Subject: Conditional Approval of Reduce Hydrologic Monitoring Sites, PacifiCorp, Deer Creek Mine, C/015/0018, Task #5770

Technical Analysis and Findings

PID: C0150018
TaskID: 5770
Mine Name: DEER CREEK MINE
Title: REDUCE HYDROLOGIC MONITORING SITES

DEER CREEK MINE WATER MONITORING ANALYSIS

Figure 1. SPI-29 spring discharge vs. PHDI Region 4 pre- and post-mining trends.

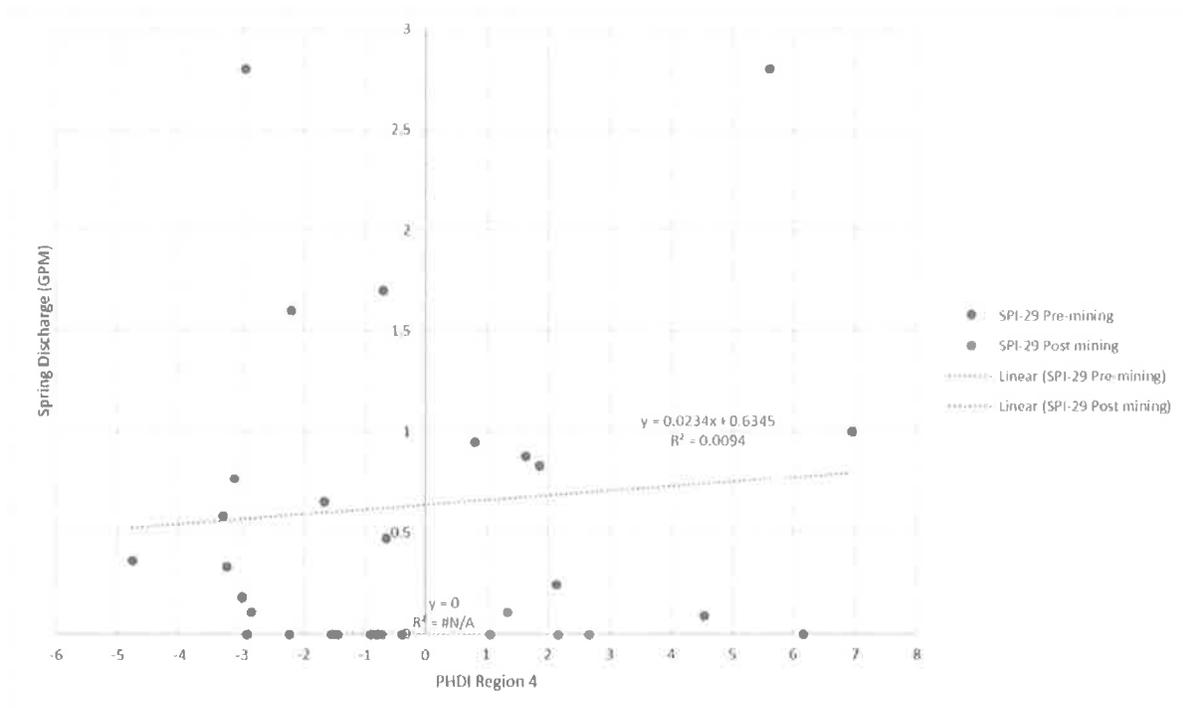
This spring has been low to no flow for the duration of monitoring and often dries up during seasonal baseflow or October monitoring. It has a small contributing area being only 500 ft to 750 ft below the hydrologic divide. The spring was not undermined and the up-gradient contributing area was not subsided. Low flows are typically difficult to accurately measure particularly in dispersed wet areas damaged by livestock such as this spring. The pre-second mining trend line is a positive slope indicating a positive climate correlation, however it is a very low R² value showing flow rates vary widely for this site. Some of the highest flows have been recorded in drought years. While all post-mining years have recorded no-flow, the site was flowing in May 2018 and at the time of the Division’s field inspection on November 8th, 2018. Flow rates observed were comparable to pre-mining discharge rates. Subsurface lateral flow paths that used to discharge at this spring source could have potentially been disrupted by the construction of the emergency road constructed just 20 feet upslope from the spring during Crandall Canyon Mine disaster relief efforts. Given the variability and dispersed nature of flows from this spring it is unlikely mining has influenced its discharge rates. This spring may be removed from the hydrologic monitoring program.

Figure 2. UJV-213 spring discharge vs. PHDI Region 4 pre- and post-mining trends.

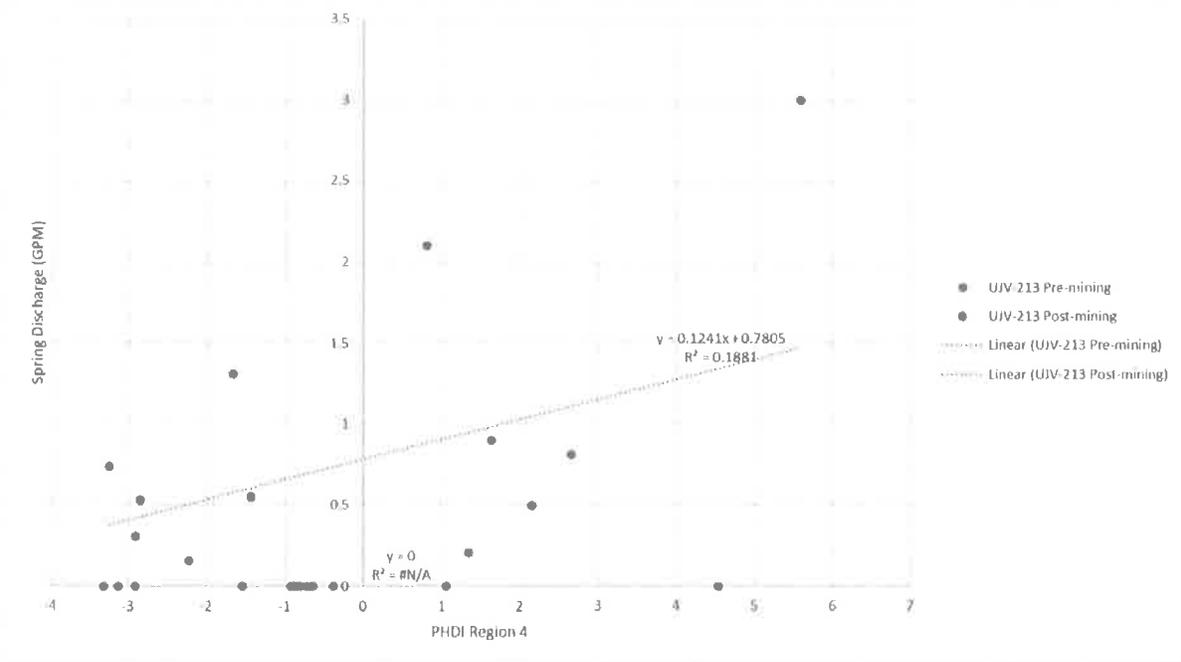
This spring is often very low flow and has been dry for a number of years. Second mining occurred east of the spring and up to two feet of subsidence occurred 400 ft away. The subsidence appears to be outside of the springs' contributing area. The Division conducted a field inspection of this site on November 8th, 2018. This springs contributing area is on a western aspect slope which is the driest aspect in the region. Western slopes are the stoss side of the prevailing winds often leaving them windblow and having less wintertime snow accumulation compared to the other three aspects. The PHDI shows the area has been in a drought beginning in 2012, probably affecting or drying out western aspects the most. Give all these variables it is unlikely mining has influenced its discharge rates. This spring may be removed from the hydrologic monitoring program.

Figure 3. UJV-101 spring discharge vs. PHDI Region 4 pre- and post-mining trends.

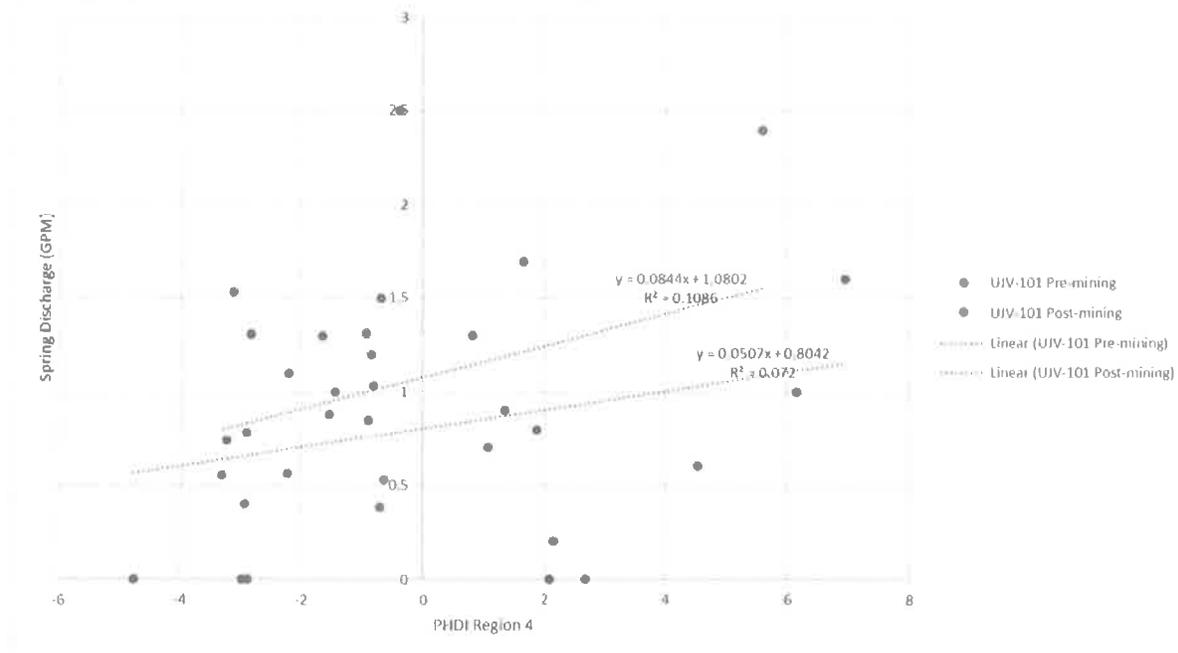
Flows for this spring range from 0 to 1.7 GPM. The Division conducted a field investigation of this spring in October 2018 and found flows comparable to reported values. First mining took place under this spring for the bleeders running parallel and adjacent to the Joe’s Valley fault. The closest subsidence of two feet is 200 ft away to the south. Both pre- and post-mining trend lines of flow vs. PHDI are positive and have similar slopes indicating mining did not likely impact spring discharge rates. This spring may be removed from the hydrologic monitoring plan.

Figure 4. JV-34 spring discharge vs. PHDI Region 4 pre- and post-mining trends. Spring not undermined and west of Joe's Valley fault.

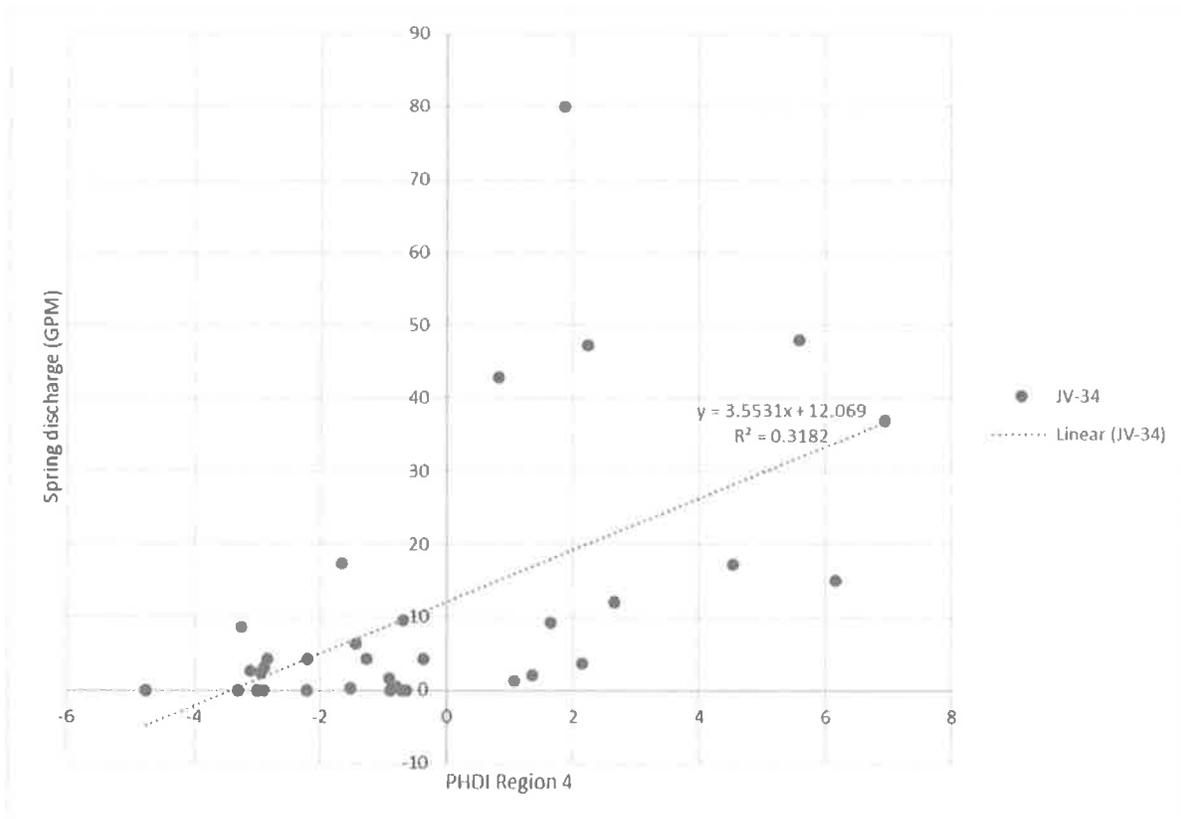
This spring is one of many discharging near the base of the alluvial fans extending off East Mountain and down into Joe's Valley. Since this spring is to the west of the Joe's Valley fault no mining took place in the area. Spring discharge rates appear to drop off in 2012 and do not recover. This is the same time period the area transitioned into drought which may be causing these lower flow rates. The trend line of spring discharge vs. PHDI has a positive slope. No zero flow values have been recorded for this spring when the PHDI is above zero. Spring discharge rates appear to be unaffected by mining activities. This spring may be removed from the hydrologic monitoring plan.

Figure 5. JV-9 spring discharge vs. PHDI Region 4 pre- and post-mining trends. Spring not undermined and west of Joe’s Valley fault.

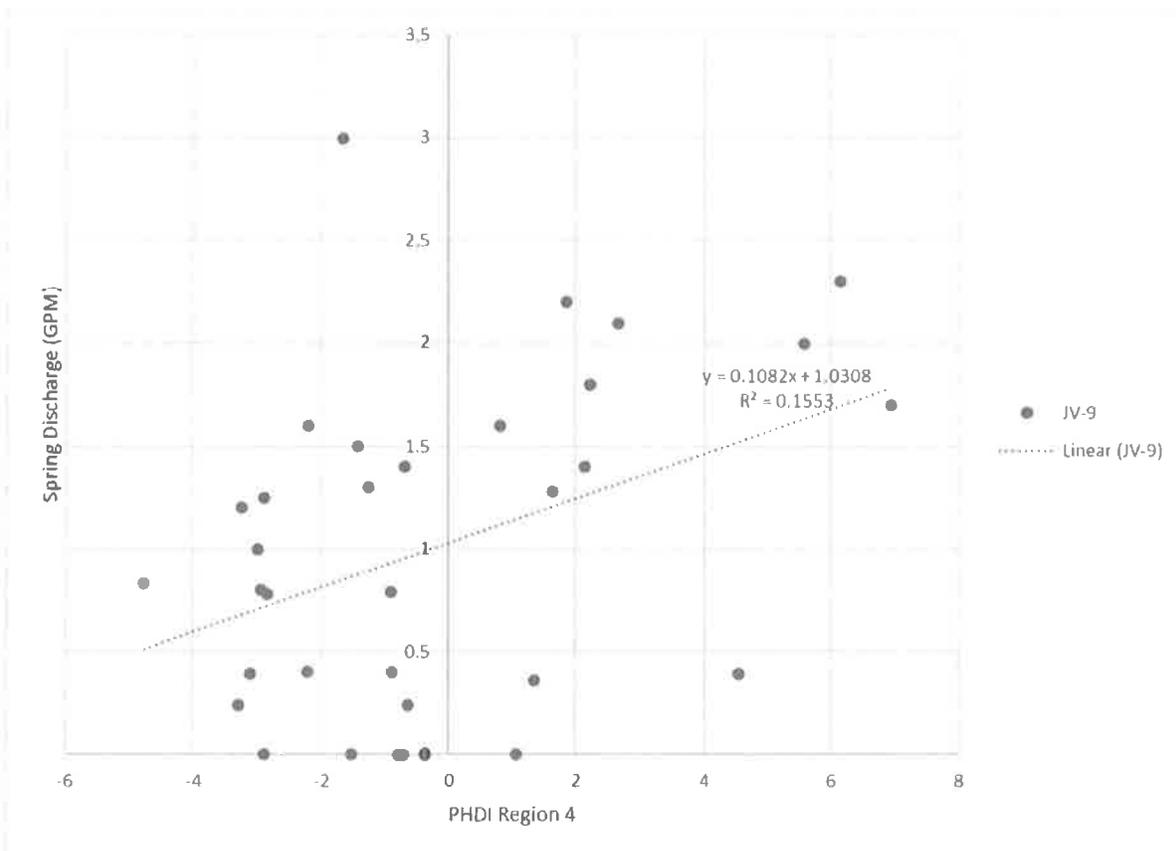
This spring sits within the same spring discharge zone as JV-34. It is at the base of an alluvial fan deposited in Joe’s Valley. It is to the west of the Joe’s Valley fault so no mining took place within the area of the spring. Spring discharge rates have always been low and have been recorded as zero a few times within the past couple years most likely due to the drought. The trend line of spring discharge vs. PHDI is positive, but flow rates are a bit more scattered than JV-34. Spring discharge rates appear to be unaffected by mining activities. This spring may be removed from the hydrologic monitoring plan.

Figure 6. UJV-206 spring discharge vs. PHDI Region 4 for pre- and post-mining that occurred nearest to the spring.

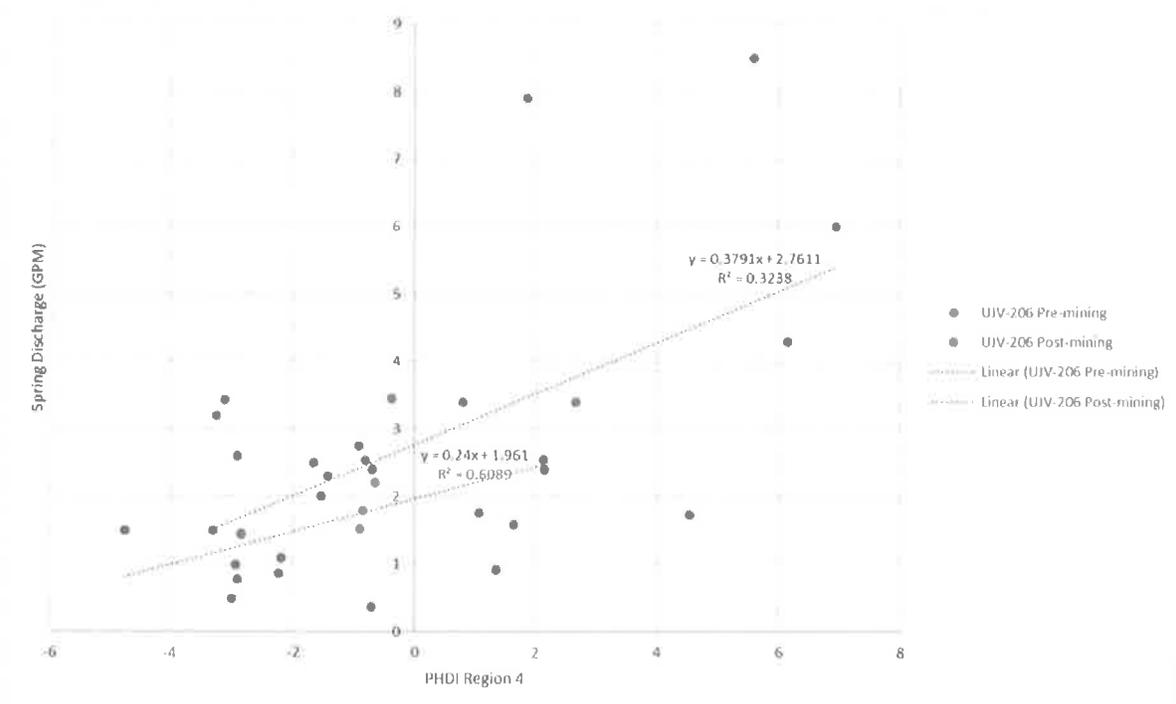
This spring is near the southwestern corner of the Mill Fork lease. First and second mining is over 1200 feet away and occurred in 2005. Both pre- and post-mining trend lines of spring discharge vs. PHDI have positive slopes. Flow rates range from just under 1 GPM up to 6 GPM. The spring has a water right and is used as a water source for a cabin and a watering trough. Spring discharge rates appear to be unaffected by mining activities. This spring may be removed from the hydrologic monitoring plan.

Figure 7. MF-219 spring discharge vs. PHDI Region 4 pre- and post-mining trends.

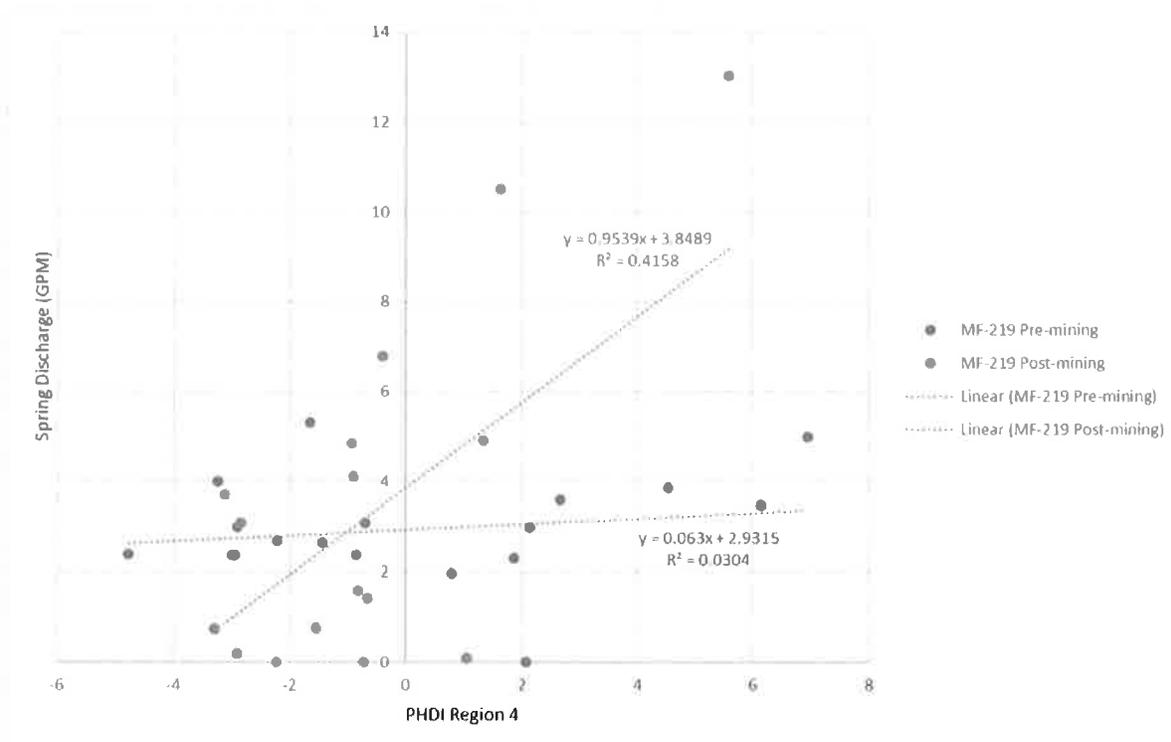
First and second mining in the Blind Canyon seam took place under this spring. First mining in the Hiawatha took place under it as well. Subsidence occurred close by to the spring with an offset of up to 14 ft. As seen in Figure 7 post-mining flows have actually increased relative to Region 4 of the PHDI. The graph in the amendment shows the spring discharge has tracked East Mountain precipitation and the PHDI without being affected by mining. Discharge rates range from 0 to 13 GPM and the spring has continued to discharge at a steady rate following mining activities. Spring discharge rates appear to be unaffected by mining activities. This spring may be removed from the hydrologic monitoring plan.

Figure 8. SPI-26 spring discharge vs. PHDI Region 4 pre- and post-mining trends. Pre- and post-mining datasets are divided around the same timeline of MF-219.

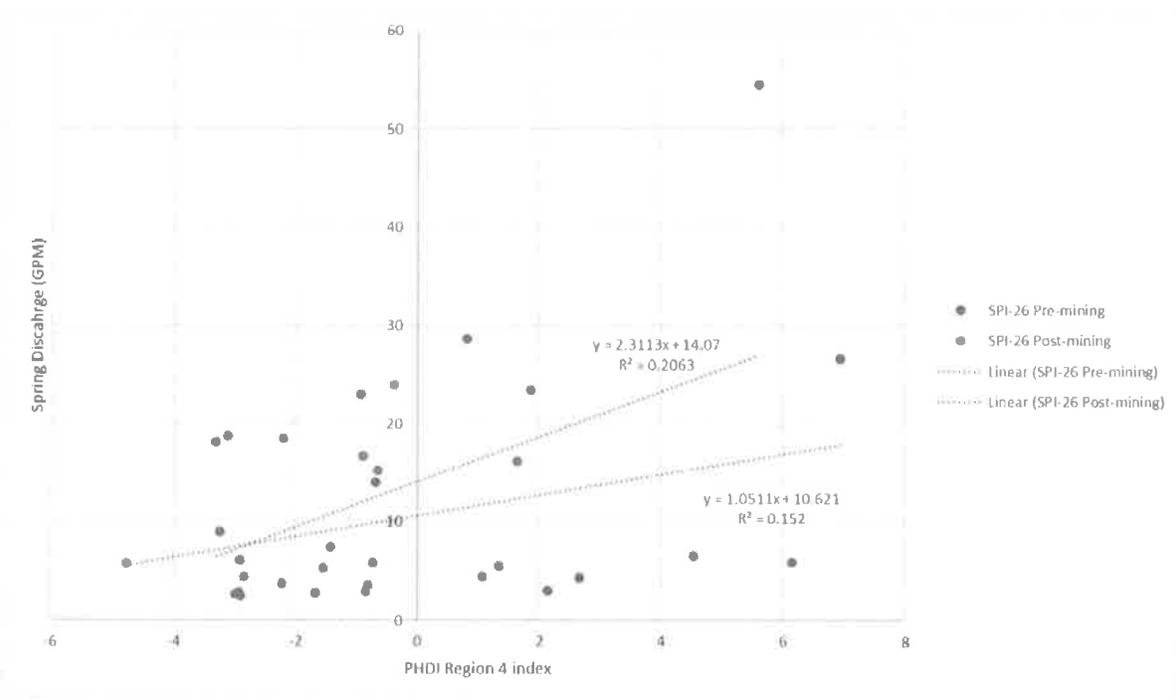
This spring was not undermined. First mining took place more or less surrounding this spring for headgates, tailgates and endgates in both the Hiawatha and Blind Canyon seams. The closest subsidence is a few hundred feet to the east. While this spring was not undermined adjacent active mining took place around the same time as first mining in the Blind Canyon under MF-219. For this reason, graphed spring discharge is broken into a similar time data set as MF-219. The USFS water right 93-1410 is associated with this spring. It appears spring discharge has increased since active mining has occurred. Spring discharge rates appear to be unaffected by mining activities. This spring may be removed from the hydrologic monitoring plan.

Figure 9. MF-10 spring discharge vs. PHDI Region 4 pre- and post-mining trends. Pre- and Post-mining datasets are divided at the time of 2009 second mining in Blind Canyon seam.

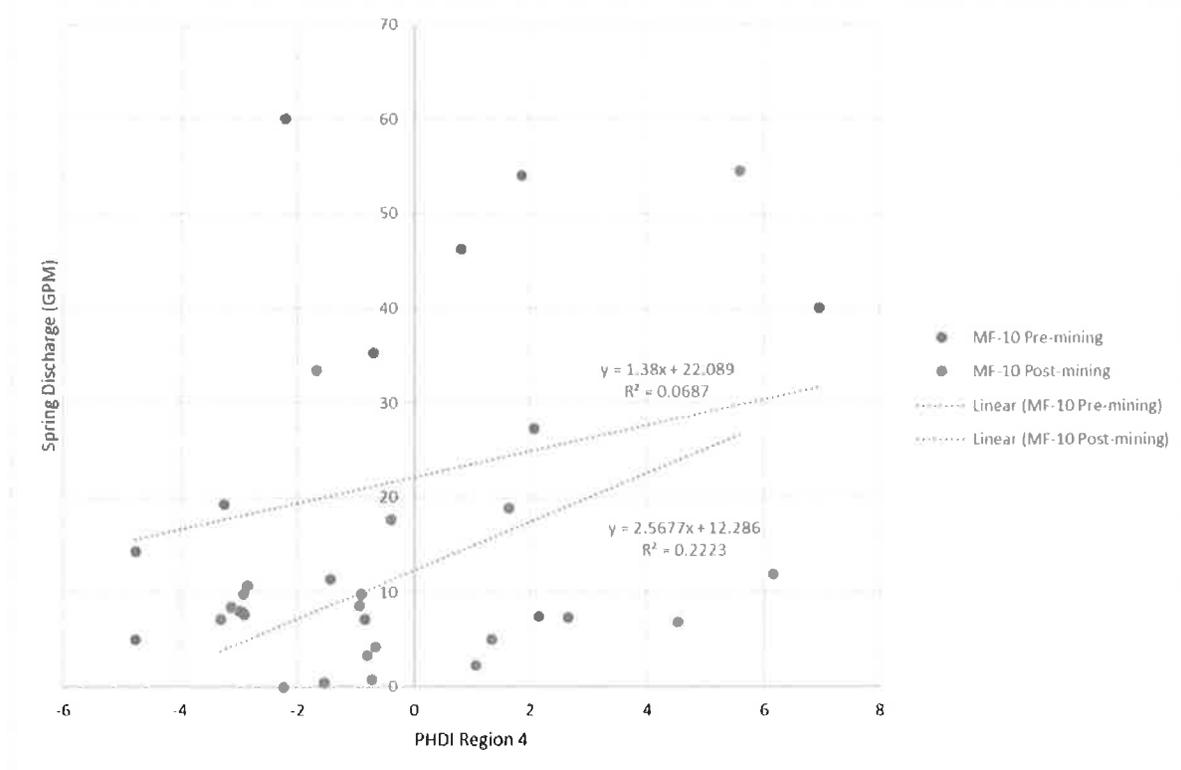
This spring was subsided by roughly 4 feet. Second mining took place in both the Blind Canyon and Hiawatha seams underneath this spring. Graphed spring discharge vs. the PHDI shows flow has trended higher after subsidence. Flows appear to be stable through time and have ranged from low single digits in GPM to as high as in the 40's and 50's GPM. The USFS has water right 93-1412 associated with this spring. Spring discharge rates appear to be unaffected by mining activities. This spring may be removed from the hydrologic monitoring plan.

Figure 10. MF-19B spring discharge vs. PHDI Region 4 pre- and post-mining trends. Pre- and Post-mining datasets are divided at the time of first mining in 2006 in the Hiawatha seam.

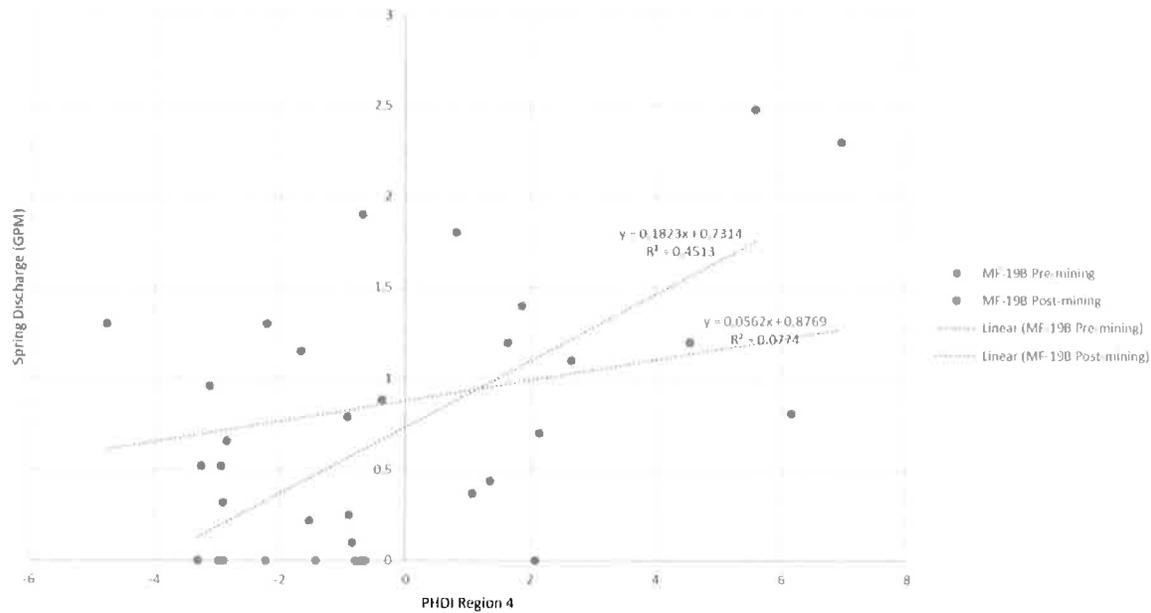
The spring is above the sump area for the Mill Fork lease. It has only been first mined in the Hiawatha seam over 12 years ago. Graphed spring discharge vs. the PHDI shows flow has trended higher after mining in the area. Flows have always been relatively low at this site at only a few GPM, but appear to be stable through time. The USFS has water right 93-1413 associated with this spring. Spring discharge rates appear to be unaffected by mining activities. This spring may be removed from the hydrologic monitoring plan.

Figure 11. RR-5 spring discharge vs. PHDI Region 4 pre- and post-mining trends. Dataset is broken between pre- and post-mining around the time of nearby second mining in 2009.

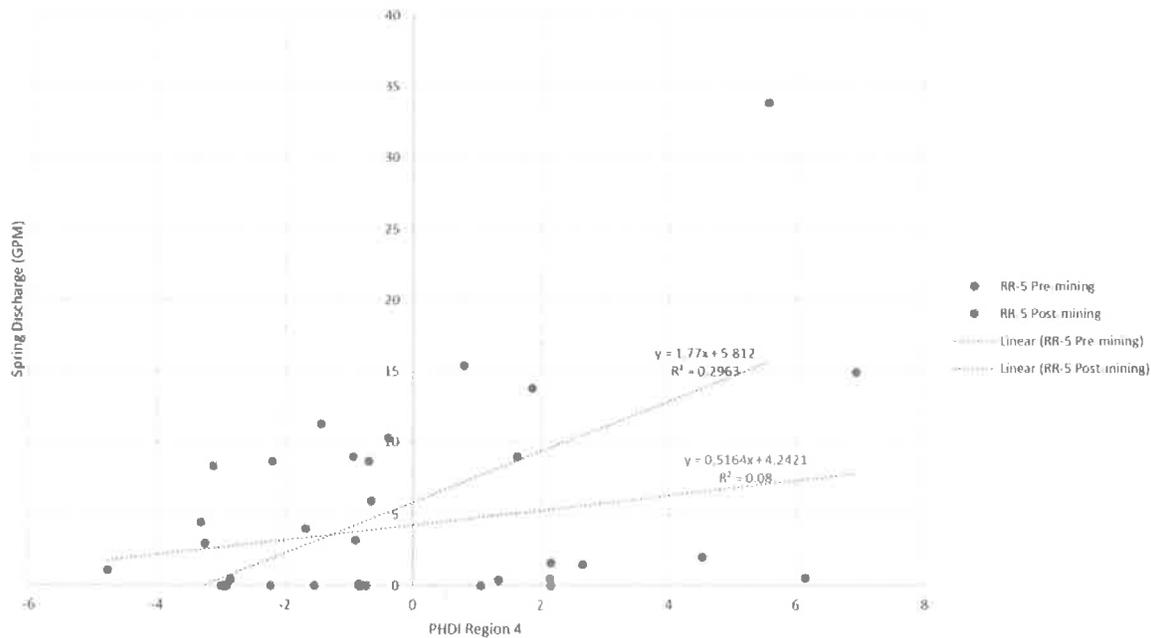
This spring has not been undermined nor has the contributing catchment. First mining has taken place in the Hiawatha and Blind Canyon near this spring. The nearest second mining to this spring took place in 2009. The trend of this spring relative to the PHDI appears to have gone up since mining. Flows have been relatively consistent from this spring through time staying mostly within single digit GPM but it has spiked up past 30 GPM following mining. The USFS has water right 93-1571 associated with this spring. Spring discharge rates appear to be unaffected by mining activities. This spring may be removed from the hydrologic monitoring plan.
